June 20, 2014

Subject: IRP Manager's Comments Regarding Letter entitled "Technical Memo, *Former Waste Pit Groundwater Investigation Pacific Gas and Electric Company, San Bernardino County*" issued by California Regional Water Quality Control Board, dated June 3, 2014

Location of the Former Waste Pit Area Relative to the Groundwater Monitoring Points Proposed in the Water Board's Investigative Order R6V-2014-0019

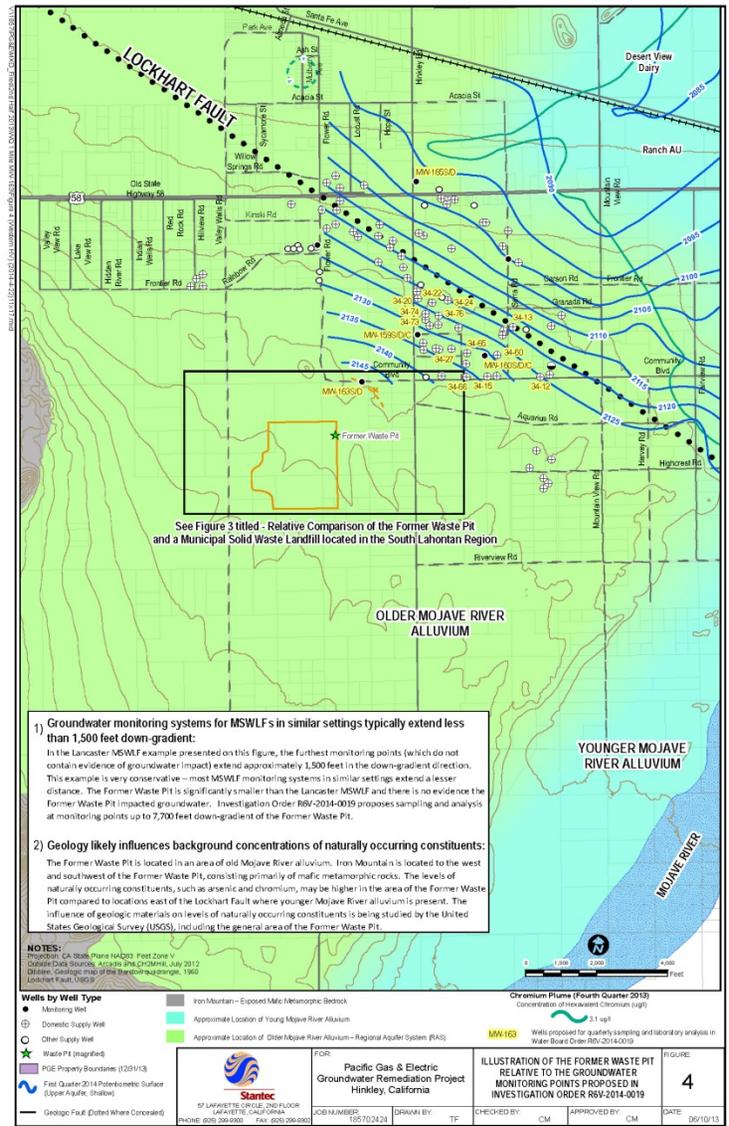
Shown in **Attachment 1** are the locations of MW-163S/D and the rest of the sampling points from IO No. R6V-2014-0019. It should be noted that most of the domestic and monitoring wells that were requested to be sampled in IO No. R6V-2014-0019 were already sampled during the 1st Quarter of 2014 as part of the overall Groundwater Monitoring Program for PG&E's Compressor Station's Discharge assessment. Since the majority of the wells (except for the domestic wells 34-20, 34-60 and 34-76) are already being sampled under the Program, the effort to analyze for the additional constituents required in IO No. R6V-2014-0019 may not be significant. Therefore, ***the CAC wishes to see the sampling plan established in the Water Board's IO No. R6V-2014-0019 implemented at the Former Waste Pit area, and replace the sampling plan described in the Water Board's Letter.***

Furthermore from their technical learning and discussions with the IRP Manager, the CAC would like to see the following wells considered or installed for sampling:

- Domestic well 34-25 located near the Former Waste Pit area (starting 3rd Quarter 2014) – Historically, this well has reported Cr6 and CrT levels above 6.0 ppb.
- One new well located upgradient of the Former Waste Pit - The CAC realizes that there is no monitoring well upgradient of the Former Waste Pit to establish a baseline for groundwater quality near the Former Waste Pit area. The CAC suggests that a minimum of one monitoring well be installed and monitored.
